Clyst Valley Regional Park

Master Plan Draft Public Consultation (Dec 2020)

Exeter Cycling Campaign

Figure 7.2: Primary and secondary riding positions

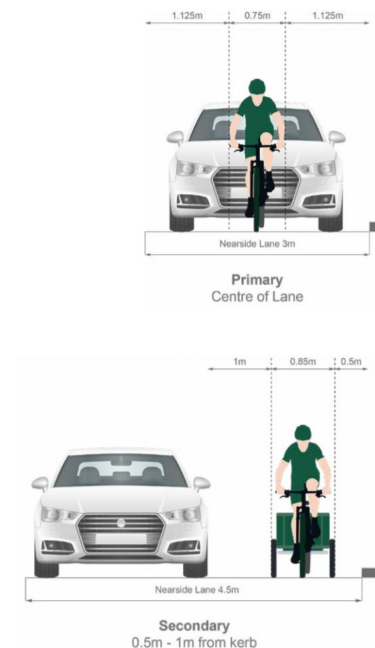
Without traffic data or the specific standards to which you are planning the use of Quiet Lanes we are unable to comment on specific sections. We would highlight the speed requirements of <35mph at the 85 percentile from the DfT Circular 02/2006 and the width requirements of LTN1/20 section 7.2 which illustrates and documents the minimum widths required for overtaking.

Figure 3.4 Indicative dimensions of typical 'non-standard' cycles

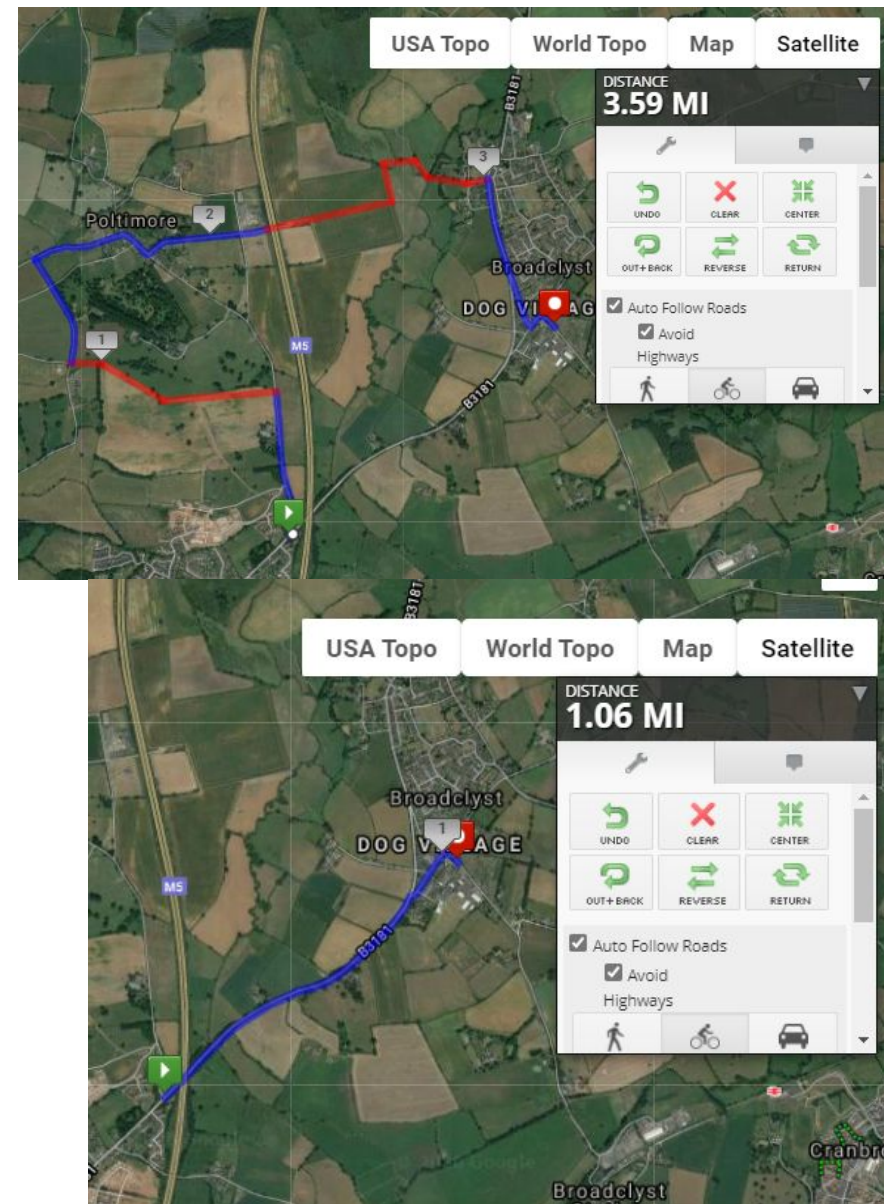
- The E2 between Westclyst and Broadclyst - pictured. Narrow as well as usually overgrown, beside a very busy 40mph road. It is shared use, with long sections where it is impossible for a lone pedestrian to pass a single standard bicycle, let alone enabling a child's buggy, wheelchair, trailer or adapted bicycle to use it.
- The off road trail between Broadclyst and Killerton house - narrow sections, extremely poor surface and with gates that are difficult to manage with non-standard bikes.
- Topsham road - high accident rate suggests the existing shared usage is over capacity, has poorly designed junctions or both.

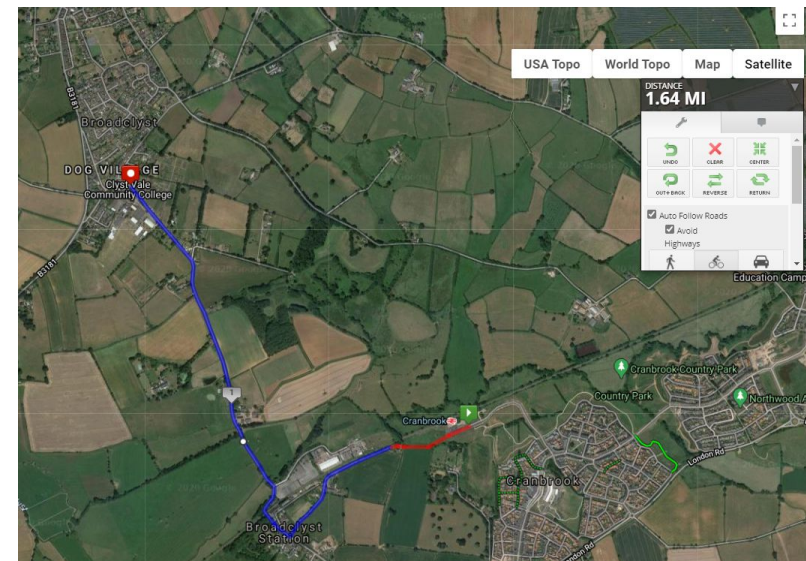
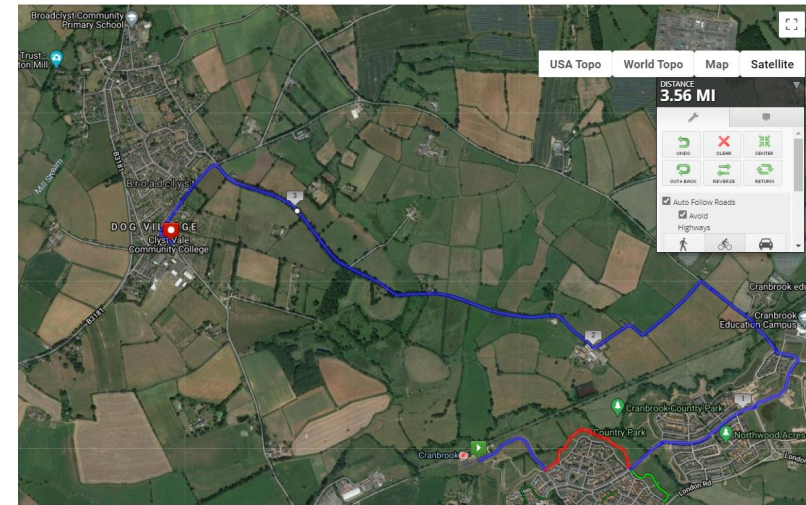
The existing route to Cranbrook along Blackhorse Lane illustrates some of the other issues beyond river / coastal flooding. Lack of formal drainage leads to mud, gravel and stones on the surface after rainfall, particularly during the winter. Lack of drainage can also lead to standing water and flooding across the entire Lane. In cold weather any standing water becomes especially hazardous as off road cycle routes and quiet lanes are not gritted. On traffic free sections the lack of vehicle traffic and insufficient cutting back of vegetation mean that the width can be quickly reduced to single person width or smaller.
